CITY OF ALLENTOWN

30321 RESOLUTION R180 – 2021

Certificates of Appropriateness for work in the Historic Districts:

Agenda Item: 2.f. **Case:** HDC-2021-00023

Property Location: 229 N. 10th

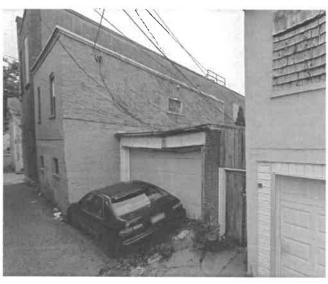
The proposed garage and demolition of a new fence will have a minor negative impact to the historic property but will not have a direct impact to the main historic building. The garage is detached from the main building and located along the rear property line. According to historic Sanborn fire insurance maps, the garage was a later addition to the property and was constructed between 1911 and 1932. It does not appear to contribute to the historic character of the main building. The wood and brick masonry structure may be original, but the garage door has been replaced and the rear windows infilled. The garage appears to be in fair to poor condition with evidence of efflorescence and open joints at the brick masonry and water infiltration at the wood roof structure. The proposed new fence is wood picket, 3 feet in height. Wood pickets are appropriate and consistent with the Guidelines. The fence is proposed to be setback from the street and a new concrete pad will be poured for a parking area.

The proposed demolition will have a minor impact to the surrounding historic district, in that it will change the existing rhythm of a rear alley within the district. The change will only be visible from the rear alley, North Hazel Street. A variety of scale, design, and materials is already present across the garages on this alley. The proposed demolition does not appear to rise to the level of a significant negative impact to the historic character of the district.

Demolition of existing structures for parking is not generally recommended. However, the existing garage does not appear to be a contributing resource to the surrounding historic district nor is it a significant feature of the main historic building. According to the Guidelines demolition criteria, a structure's location on a primary, secondary, or alleyway should be considered, as should the hierarchy of accessory structures to primary structures. The applicant stated that they consulted two licensed professionals on the feasibility of rehabilitation. It is recommended that the applicant clarify the existing conditions and these opinions of feasibility for HARB's consideration.

Motion to approve demolition of garage and partial demolition of the existing brick wall along the property edge down to knee wall height of 3'-0", repoint the wall and add a brick or cast stone coping, ensure the existing concrete pad is in good condition, repair as needed and provide adequate drainage was made by HARB member Patricia Jackson, motion was seconded by HARB member Glenn Lichtenwalner. Motion carried with unanimous support.
